PROPOSED COMPREHENSIVE PLAN AMENDMENT ADDENDUM

ITEM: SSPA 2018-1-1MS

Date of Addendum: September 10, 2019

SITE-SPECIFIC PLAN AMENDMENT 2018-I-1MS STAFF REPORT ADDENDUM

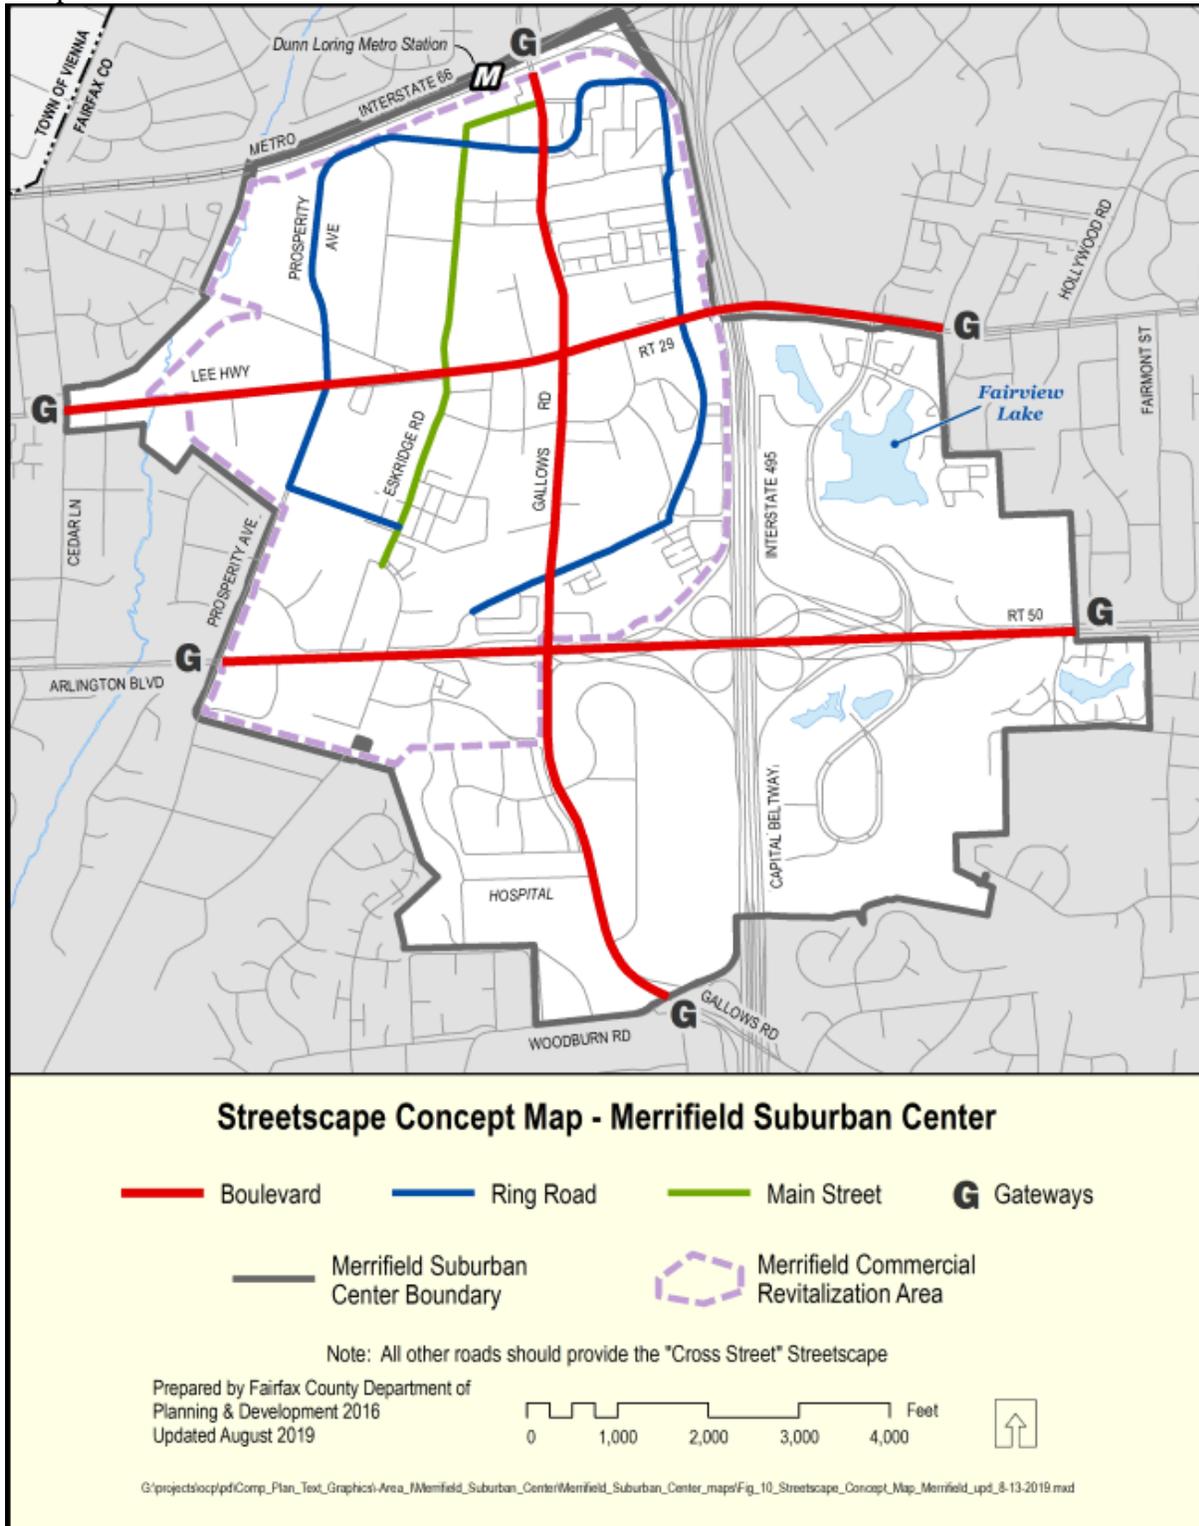
1314 **MODIFY FIGURE:** Fairfax County Comprehensive Plan, 2017 Edition, Area I, Merrifield
 1315 Suburban Center, Area-wide Guidance, as amended through July 31, 2018, Figure 10, page 28 to
 1316 move the word “HOSPITAL” further south to reflect the accurate location of Inova Fairfax
 1317 Hospital.
